North Wales Wind Farms Connection

Deadline - 17 September 2015

Interested Parties Ref: **NWWFC-AFP012 and NWWFC-AFP011**

Mr Dewi Parry and Mrs Helen M Parry

Fig.1
Plan drawing of estimated views from [redacted]

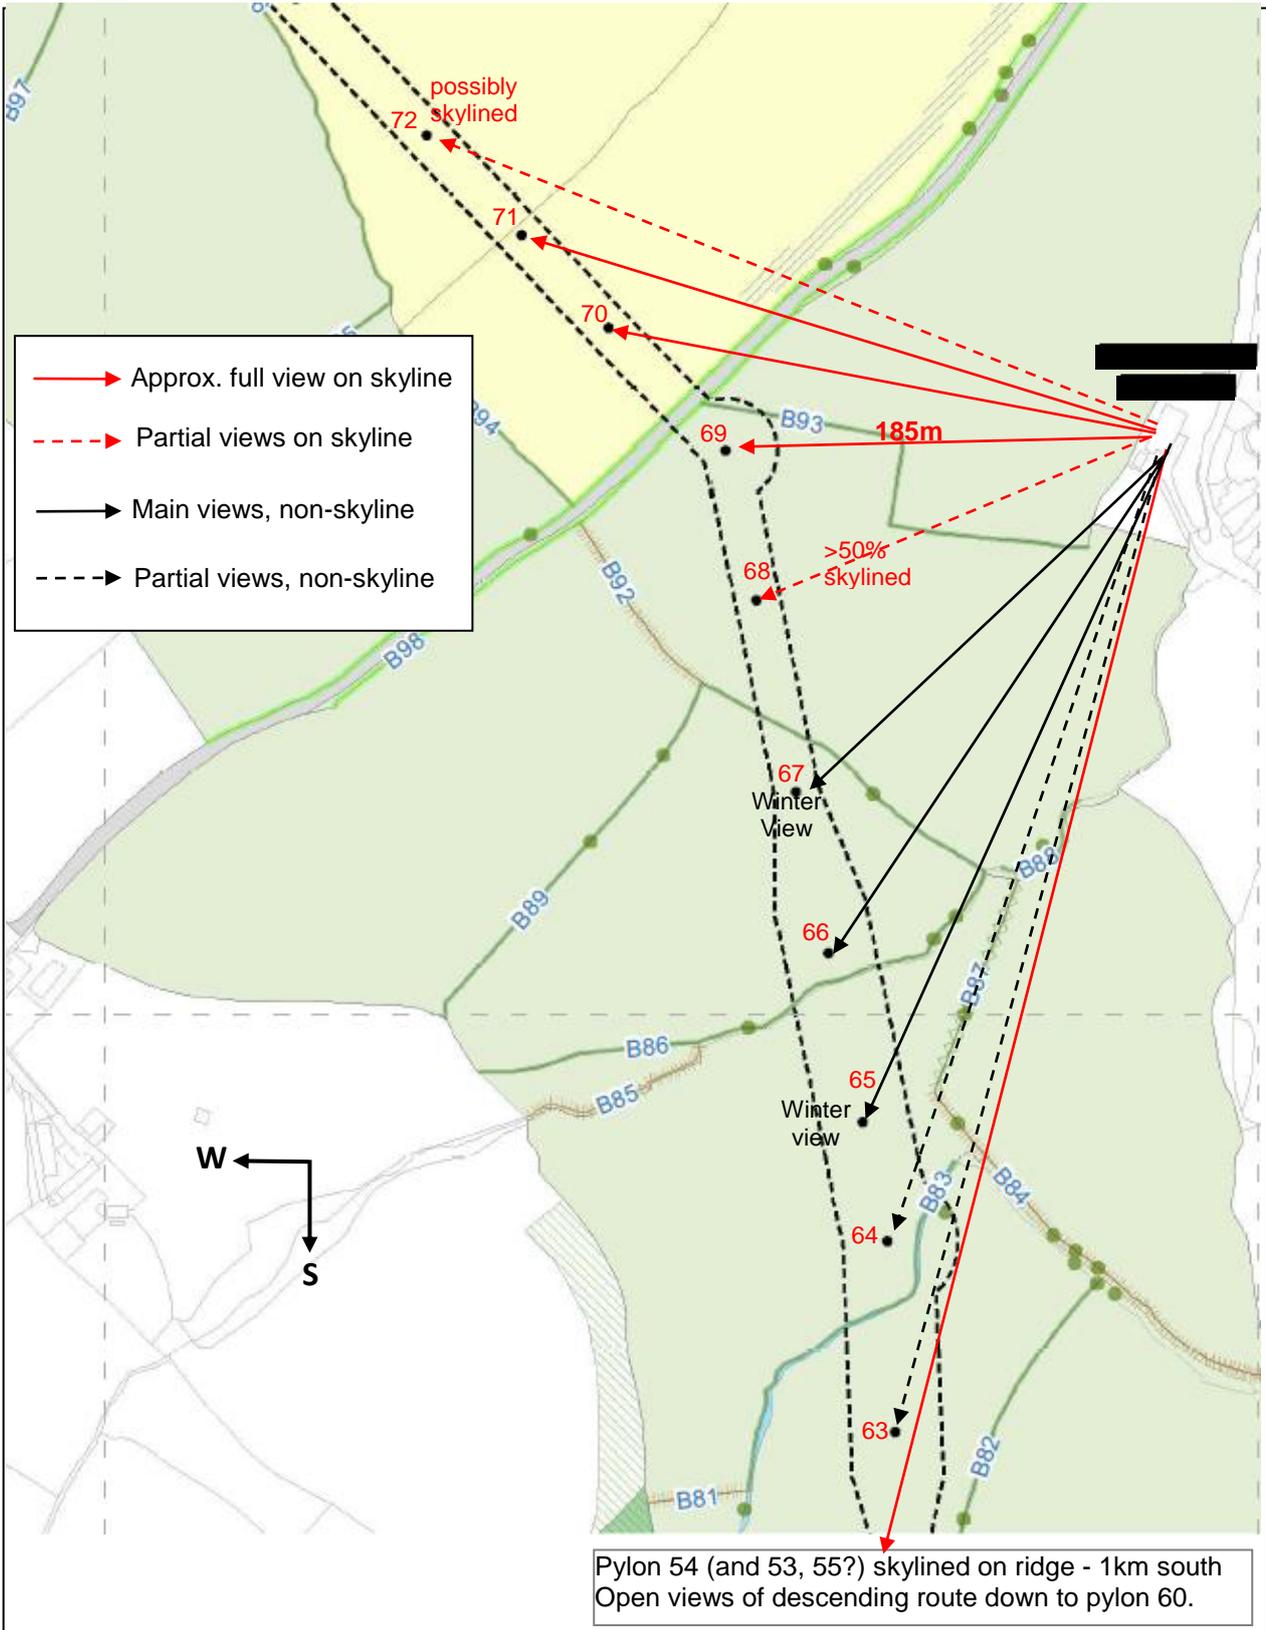
The Applicant still maintains that ‘*primary views are not orientated towards the Proposed Development*’ (16.11.57). This is not the case. As we have previously stated we have primary views from the living areas in [REDACTED] towards the route that also include two Skylines (See Figs1, 2). Windows in Kitchen, Dining Room, Living Room and one Bedroom will have uninterrupted direct views.

16.11.57. “*The proposed 132kV Overhead Line would briefly skyline as it reached the rising land adjacent to the B4501*” We restate that there are two separate skyline occurrences, one to the south and one to the west as directly viewed from [REDACTED] main room windows. The nearest skylined pylon (pylon 69) being 185m away from viewers at [REDACTED] windows (See Fig1, Fig 2). An existing

The words 'briefly skyline' are not congruent with the likely visual effect. At least four pylons are likely to skyline on the west view alone (pylons 68, 69, 70, 71). Pylon 72 may also be partly visible, but this is uncertain. Approx 200m of the overhead line extends across the west view.

Undergrounding these sections of the route would be an acceptable solution and would address all the objections we have raised.

Fig. 2

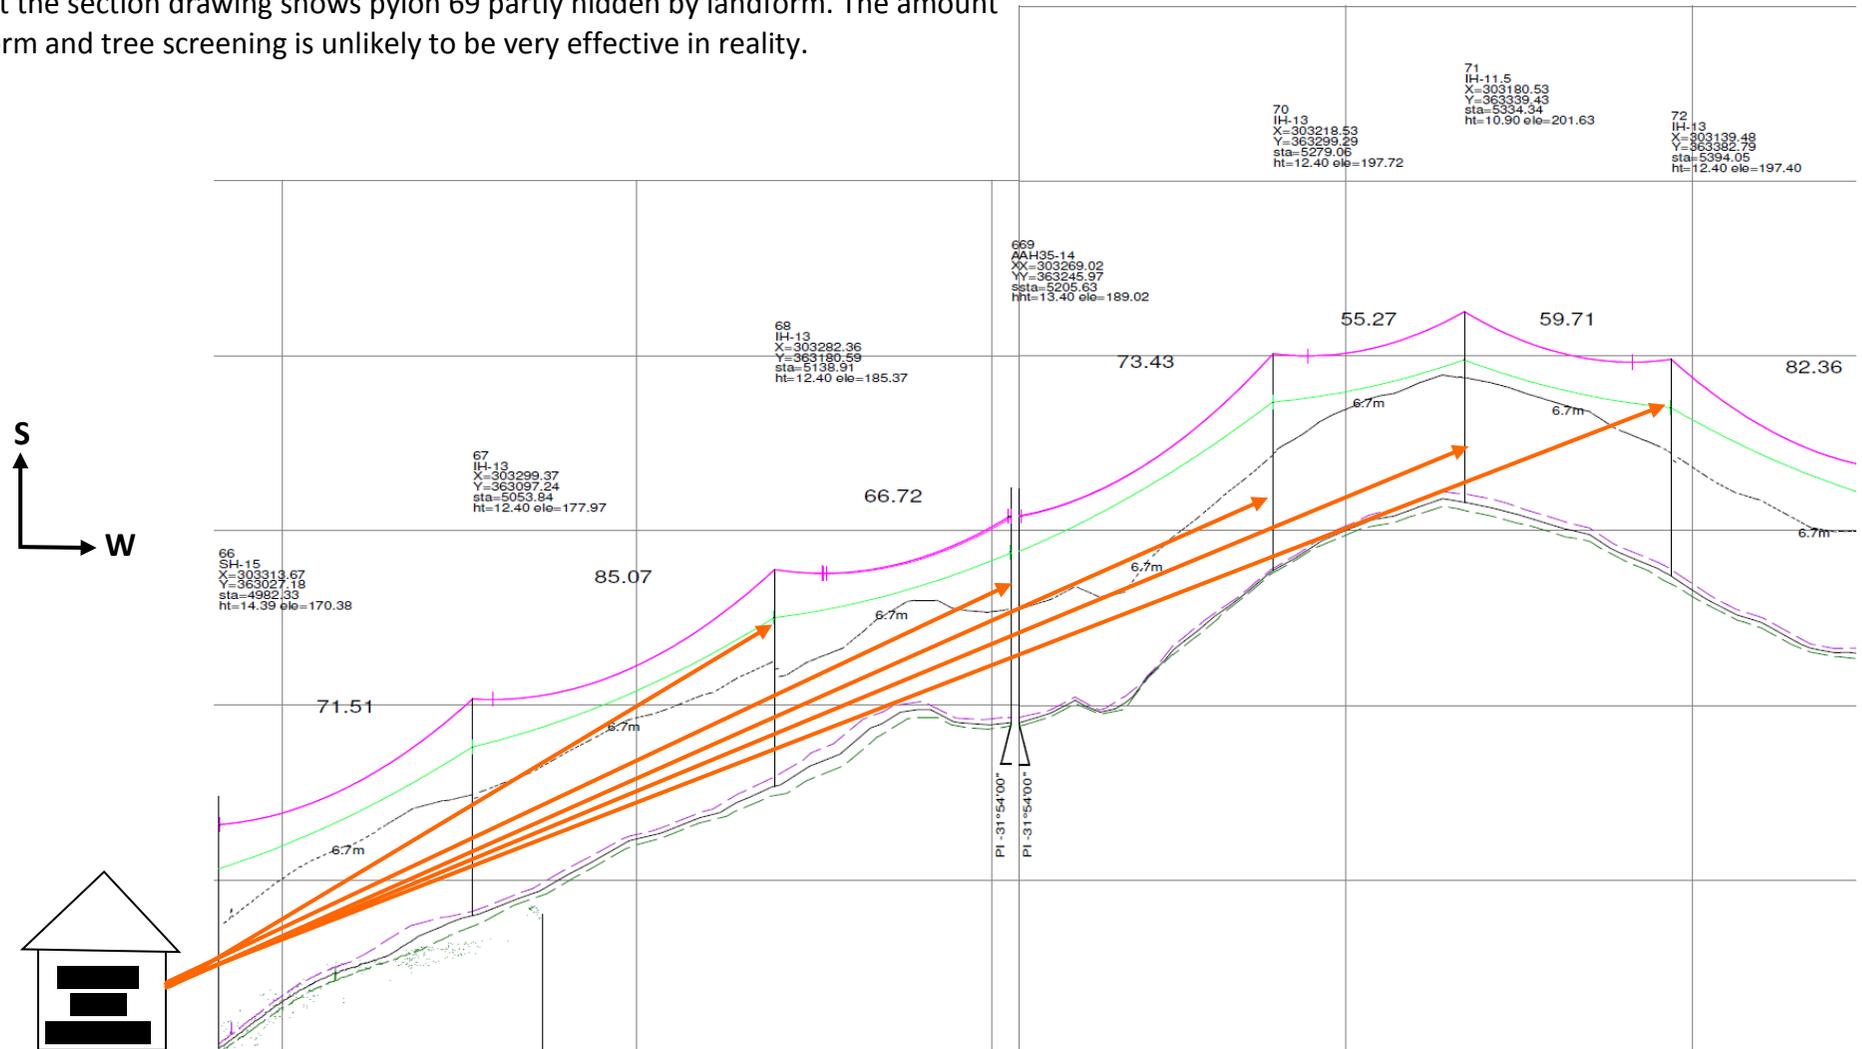
→ Skyline views of Pylons 68, 69, 70, 71, possibly 72.

Pylons 69, 70 and 71 would likely be visible almost in their entirety on the skyline.
 Pylon 68 would at least 50% skyline. Top part of Pylon 72 may or may not be visible.
 Note that the section drawing shows pylon 69 partly hidden by landform. The amount of landform and tree screening is unlikely to be very effective in reality.
